SEWAGE DISPOSAL SYSTEM

P 510224-BA REPAIR

HOWARD COUNTY HEALTH DEPARTMENT

RIDGLEY ACRES SECTION ONE LOT 2

A 510224-B

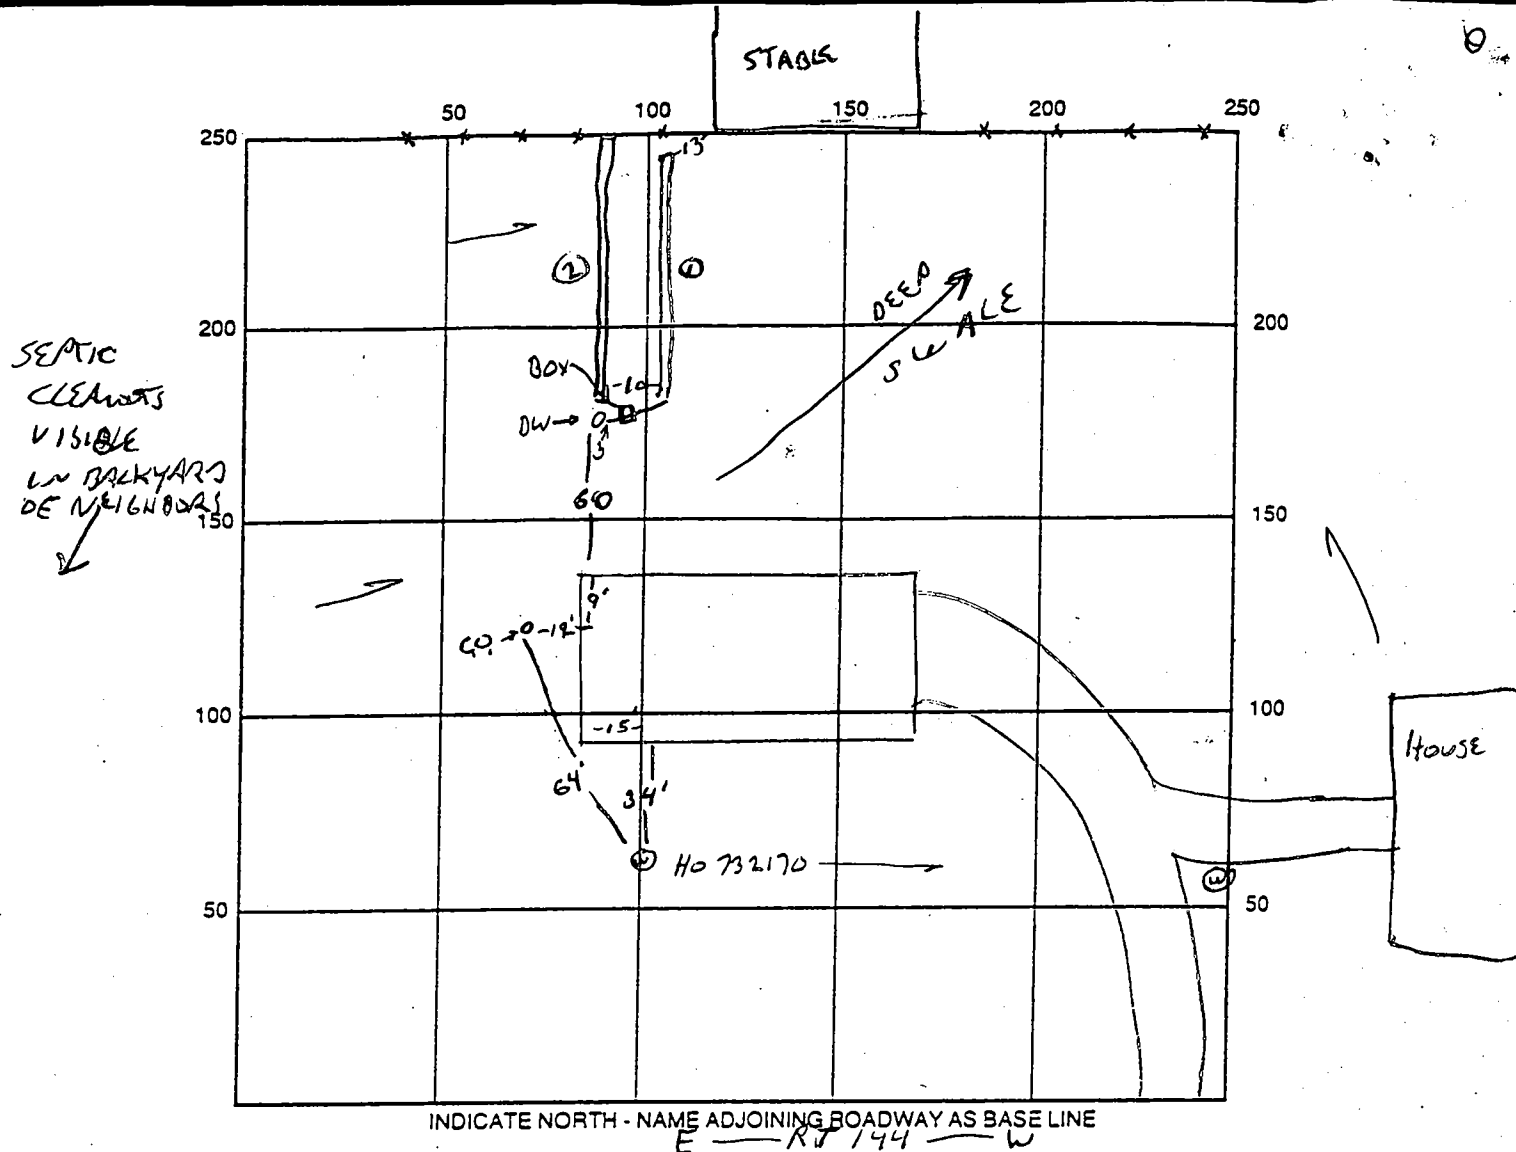
REPAIR - PURPOSE - SEPTIC SYSTEM HAS FAILED.

Call for an inspection when the ground is opened so a sanitarian can recommend repairs.

REMARKS: 7.13.98 OK TO FINISH 1ST TRENCH & 7.13 FINAL COVER

TEST HOLE DUG 15' DEEP DRYWALL, CLAY TO 3', MANHOLE LAMINATE BOTTOM, DRY.

A25961

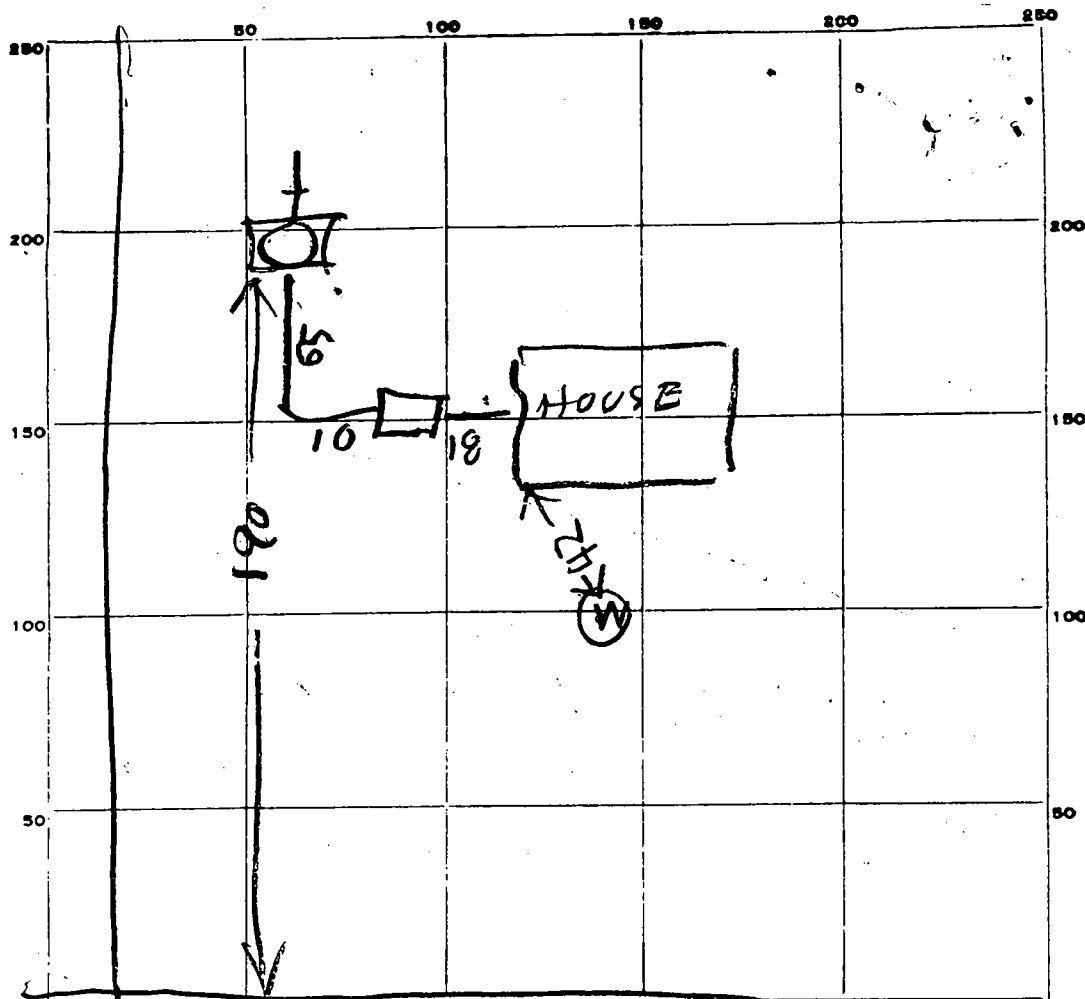
TRENCH-to be 15 ft. long for a total absorbent area of 100 sq. ft. Inlet to be 3 1/4
and maximum depth 11 ft. Come off rear of dry well, run trench directly towards rear
lot line. Keep trench on contour to keep it level.

REMARKS 3/21/78 T.S.O 1100MS; ST in & connected to house, partially completed DW. (black cover) saved in on one side. No other work done.

5/12/78 DW INLET 5 FT DEEP BELOW GRADE

OK TO PUT STONE IN DITCH COVER TANK & DW. & CALL US FOR INSPECTION OF DITCH

11/3/79 SYSTEM COVERED HOUSE VALANT RH 3/1/79 - SEE ATTACHED

A 25961

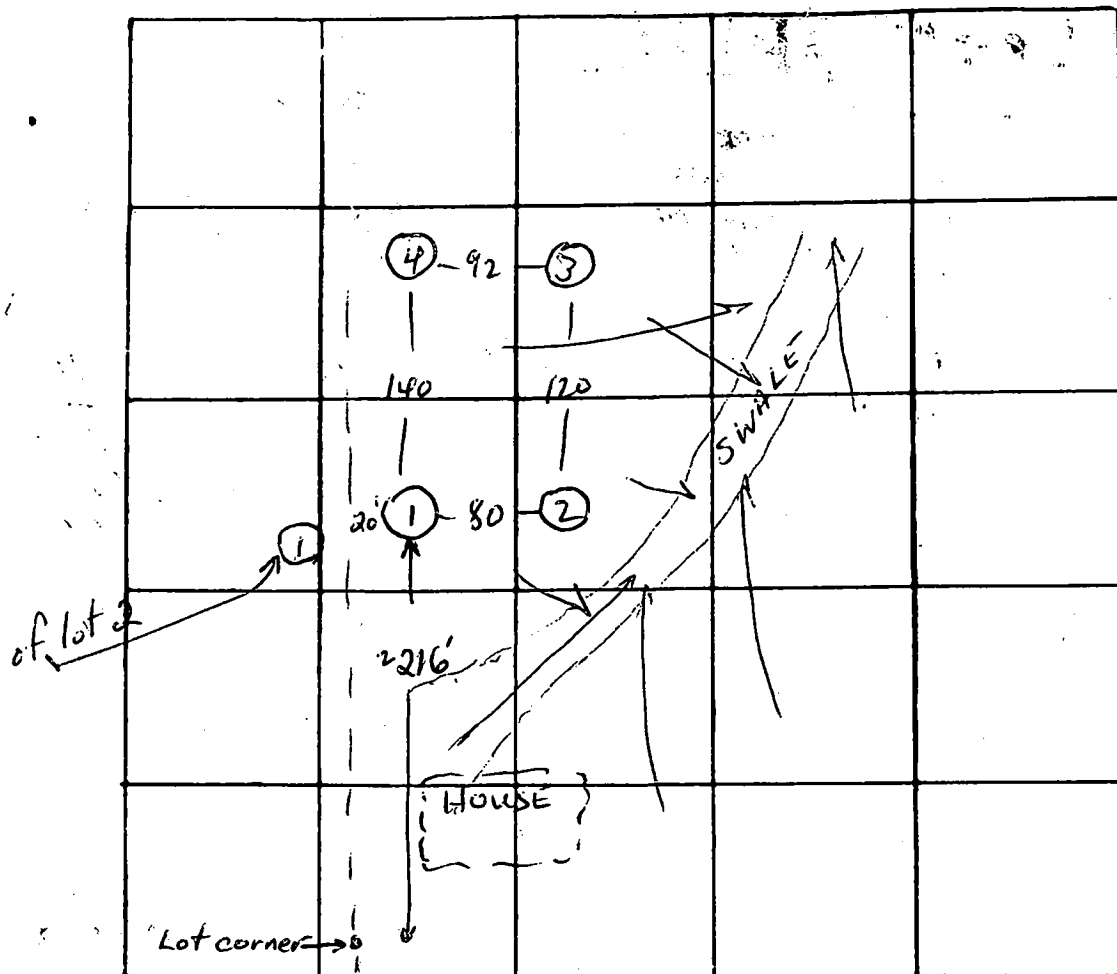
REMARKS System in 1 → 4
sewer from house will have to cross swale to get to perc area

GRADING STUDY

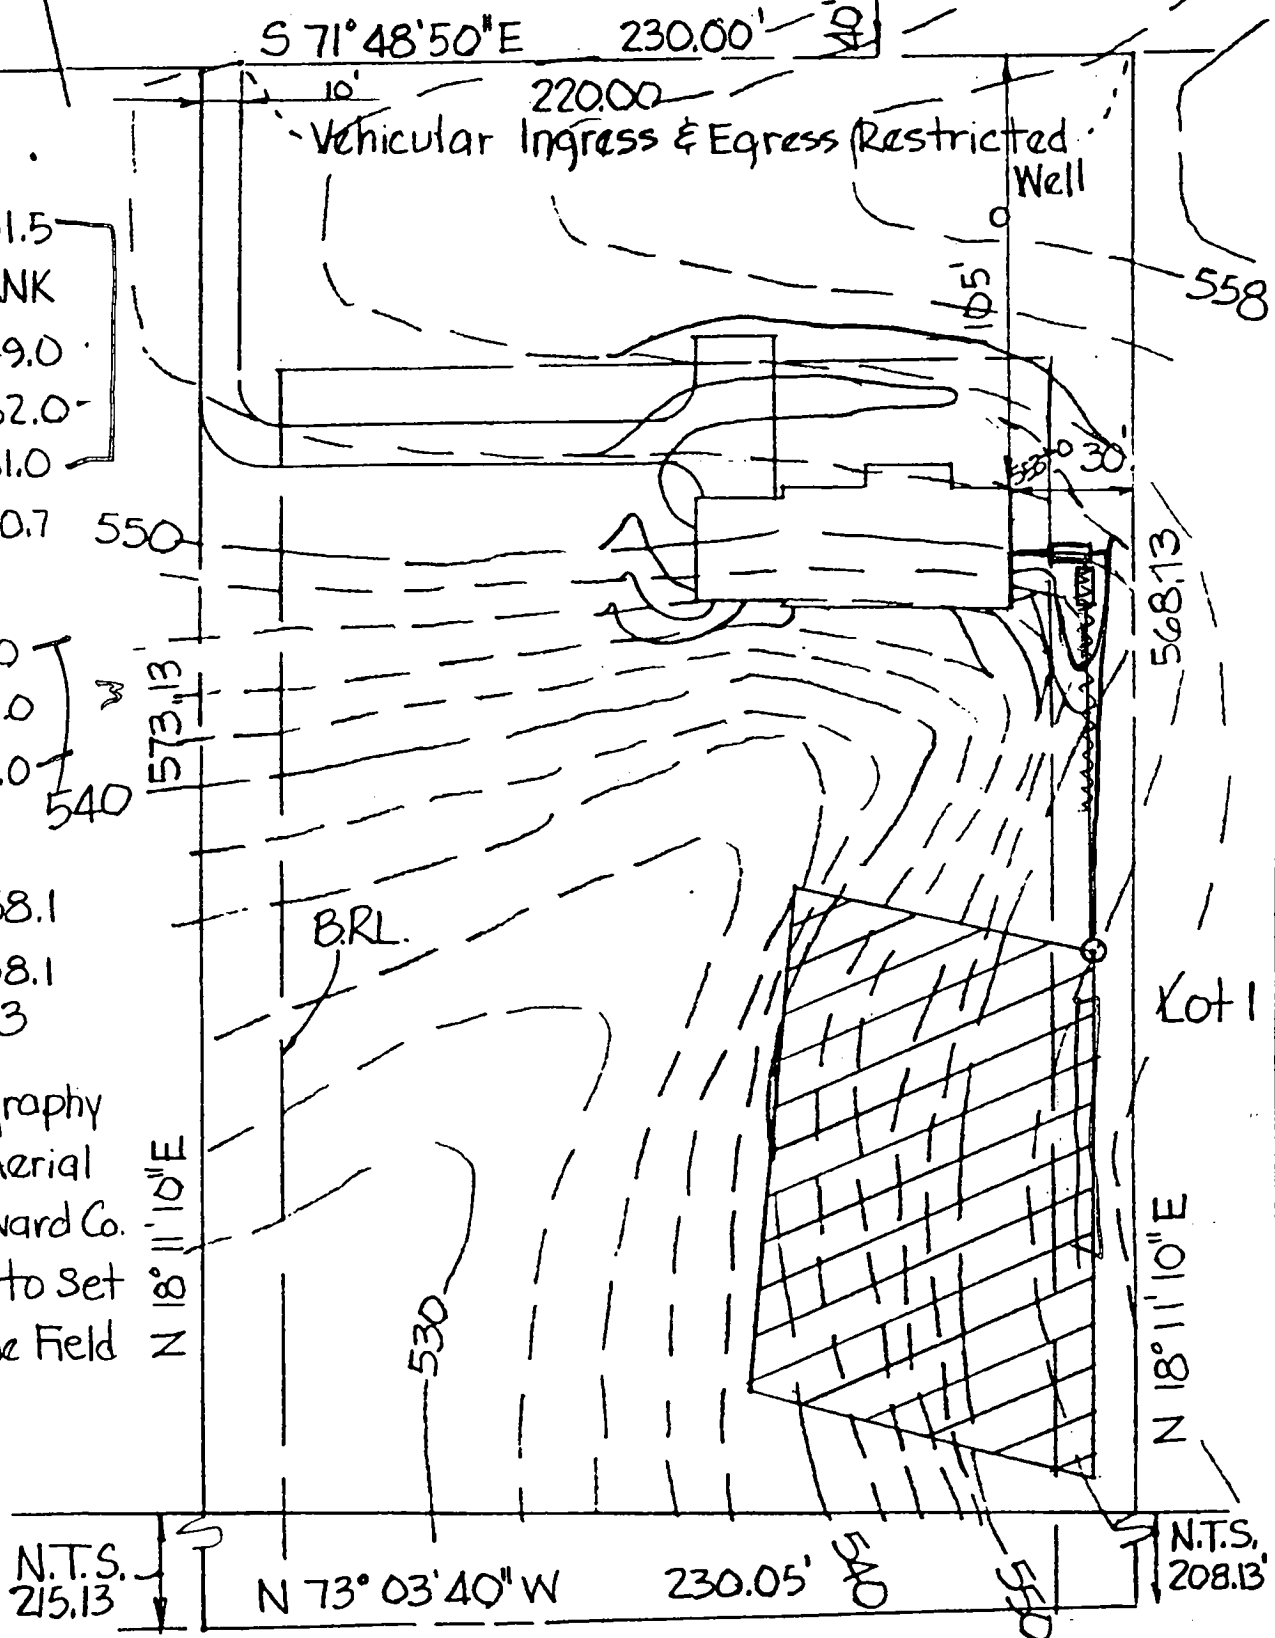
Topo shown on plat does
not agree w that actually
observed on indiv. lots.

Suggest new topo and
field located holes if
necessary.
